Friction Materials Standards Institute, Inc.

Subject: Docket No. 70-17. Notice #1
Air Brake Systems; Trucks and Buses

Subject: Docket No. 70-16; Notice #1
Air Brake Systems On Trailers

Subject: Docket 70-17 Air Brake Systems,
Trucks and Buses

TEST A

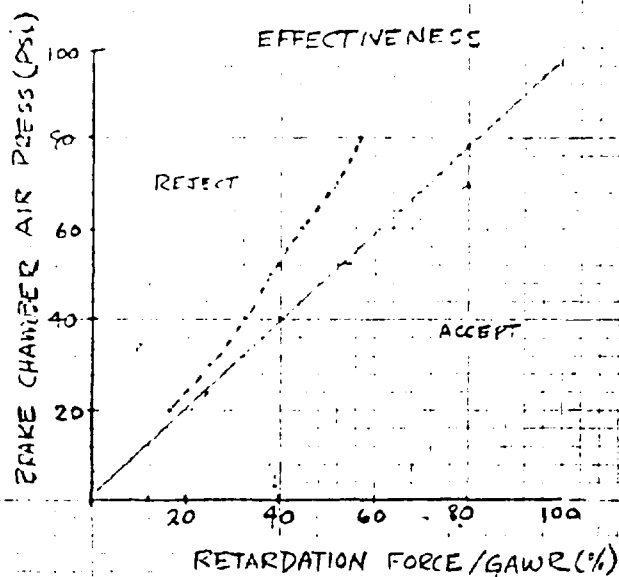
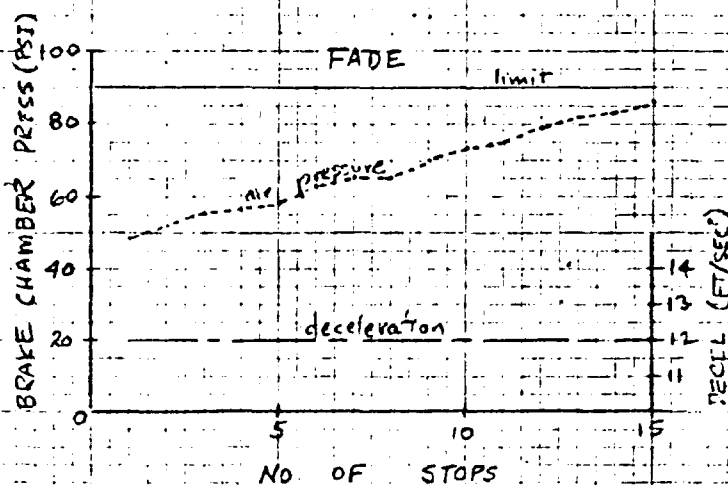
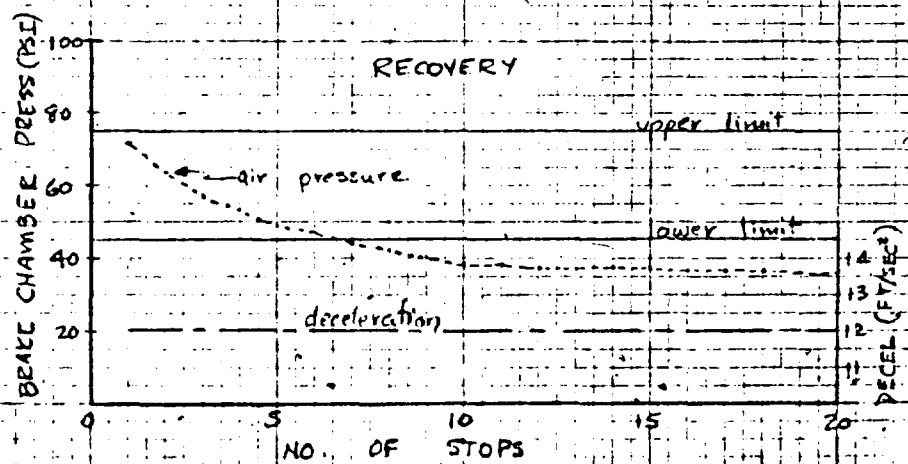
We have attached plots on each of the dynamometer tests and identified these "A" thru "J". The test conditions such as brake size, type, AL factor, wheel load, drum weight and friction material have been detailed on each plot. The first discussion will deal with the retardation force or effectiveness. The second discussion will combine brake power (fade), hot stop and recovery as we consider these closely related.

It should be noted that all tests failed to meet at least some portions of the proposed requirements. This includes variations in coefficient of friction from medium to very high, loadings, drum weights and AL factors.

In all tests the slope of the curves produced by the data does not agree with the slope of the proposed minimum acceptable line. Low pressure points nearly meet or exceed the proposal. However as pressure is increased the curve from the data falls far away from the acceptability line. We do not have sufficient data to determine if this relationship should be linear or expressed in curve form.

TEST D

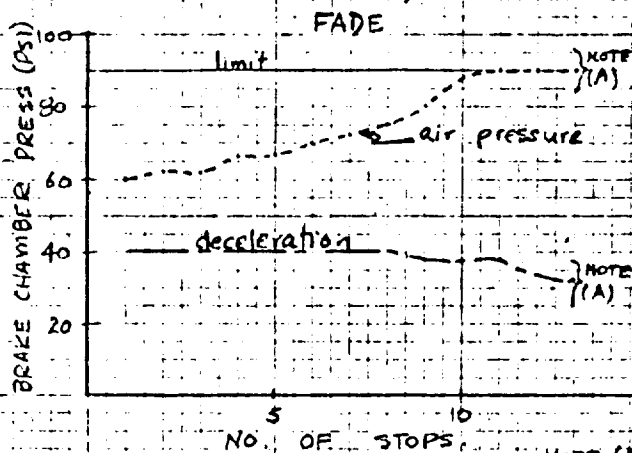
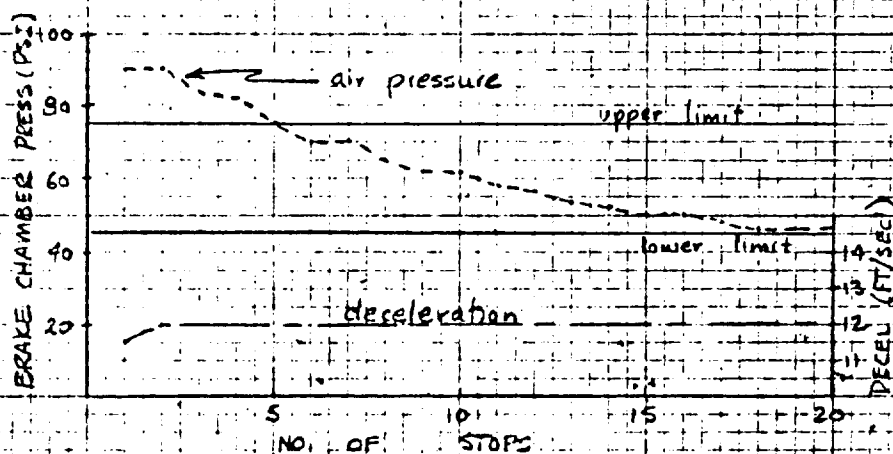
NOTE (A) - FADE TERMINATED
BRAKE AFIRE

DECELERATION AND STOPPING DISTANCE

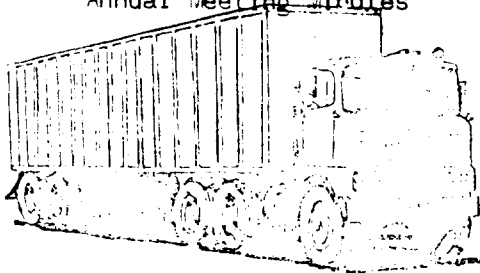
Allowing for current state of the art, a 3% fall-off in deceleration rates should be expected for each 10 MPH increase in speed. Allowing for this speed sensitivity, we believe the deceleration rates and stopping distances shown in the last two columns of this table are attainable. Without such an allowance, the speed sensitivity inherent in brakes and brake linings, is being ignored.

We wish to emphasize that with existing brake systems, brake linings cannot be expected to meet the stopping distance requirements of FMVSS #121 at the higher speeds.

Also, allowing for what we believe is an error in the 40 MPH - 108 ft requirement, we recommend that the stopping distance requirements be adjusted to allow for speed sensitivity, in line with the values shown by our tabulation.
